# UNITED STATES PATENT AND TRADEMARK OFFICE

APPLICATION NO.	FILING DATE	FIRST NAMED INVENTOR	ATTORNEY DOCKET NO.	CONFIRMATION NO.
10/801,887	03/16/2004	Ray Showers	1010-0119	4482
26568 7590 06/26/2007 COOK, ALEX, MCFARRON, MANZO, CUMMINGS & MEHLER LTD SUITE 2850 200 WEST ADAMS STREET CHICAGO, IL 60606			EXAMINER HORTON, YVONNE MICHELE	
			ART UNIT 3635	PAPER NUMBER
			MAIL DATE 06/26/2007	DELIVERY MODE PAPER

## Office Action Summary

## **DETAILED ACTION**

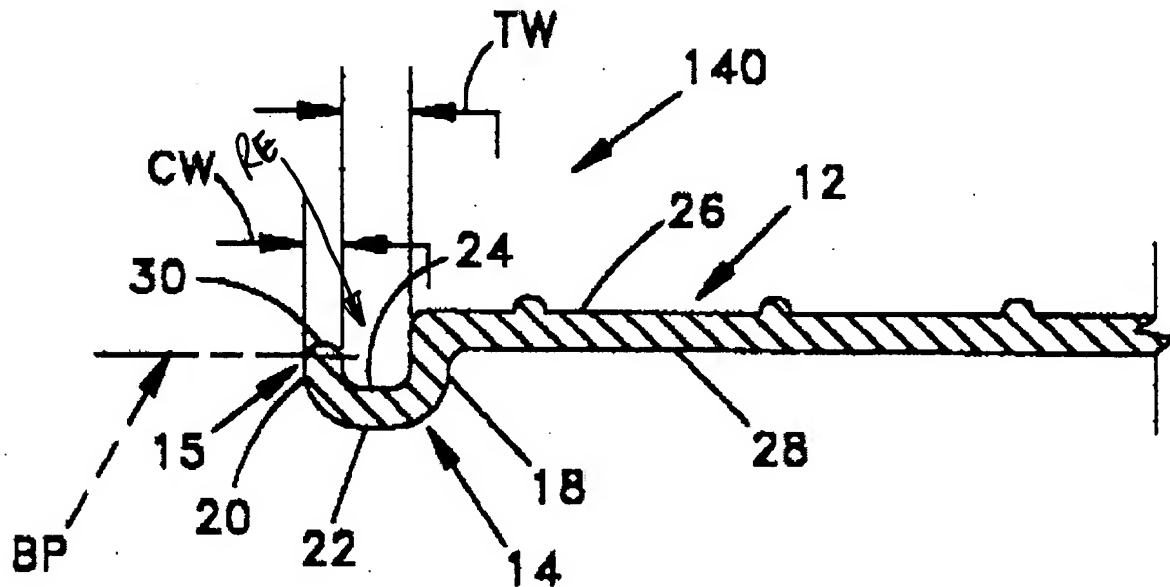
having a first locking part (16), said second edge region having a bottom surface (as at

18 & 22) which is a continuation of the bottom surface of the main body portion and also having a second locking part (14), said interlocked joint being formed by engagement

of said first locking part of said first edge region of the first board with said second locking part of said second edge region of said second board, said assembly including both a moisture drainage channel (50) and a mechanical fastener receiving surface (52) which are separated from one another at said interlocked joint, said first locking part of said first edge region includes a recessed region (RE) which faces downwardly, said second locking part of said second edge region comprises an upward projection (20) from said bottom surface of said second edge region, said recessed region has a concave shape and wherein said upward projection has a convex shape, said moisture drainage channel including a channel mouth (MO) above said upward projection, said first edge region including a laterally extending head portion (HE) which penetrates

through said channel mouth and which rocks upwardly into a moisture blocking position within said moisture drainage channel as said recessed region of said first locking part of first edge region is interlocked with said upward projection of said second locking part of said second edge region.
